PDP-8L

TECHNICAL INFORMATION
FOR INTERNAL USE ONLY

EP-PDP8L-TI-C
COPYRIGHT © 1982
FICHE 1 OF 1

ECO SYNOPSIS FOR LOGIC OR OPTION
PDP-8L PROCESSOR LOGIC **PDP-8L**

ECO #8L-00106 A-PL-8L-0-18 NEW REV L

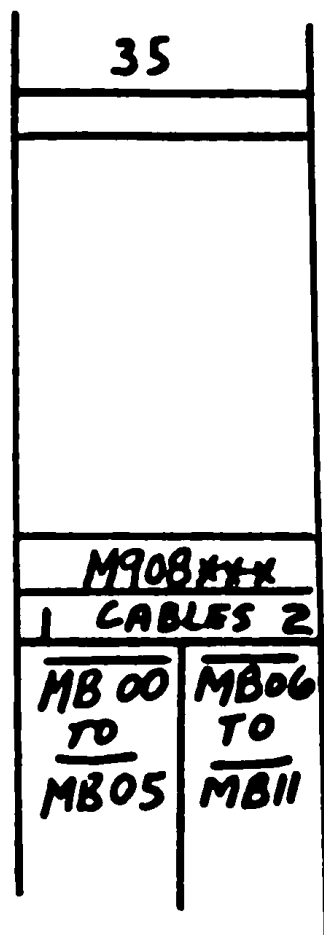
THE ~~G311~~ ^{ADD} M902-YB (TERMINATOR) IS ALWAYS PLACED AT THE END
 OF THE IO BUS FOR IOP'S, AC BITS AND ~~ADD~~ TIME STATES WHEN
^{ADD} 20 FEET OR MORE OF CABLE IS USED. WHEN THERE ARE NO
 OPTIONS THE ~~G311~~ ^{ADD} M902-YB IS PLACED IN LOCATION D36.

Title					Tech Tip				
8L AFFECTED BY EXTERNAL NOISE					Number PDP8L-TT-7				
Processor Applicability					Author W. Freeman				
All					Rev g				
8L					Approval W. E. Cummins				
					Date 11/14/73				
					Cross Reference

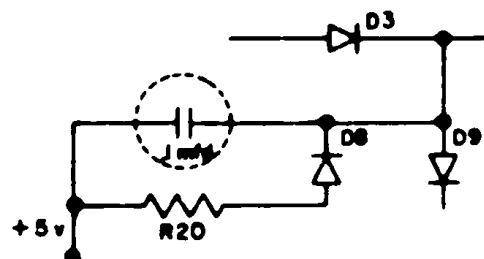
If external noise from surrounding equipment is affecting an 8L, the installation of a .1 mfd. capacitor on the G785 module as shown in the schematic below will resolve the problem.
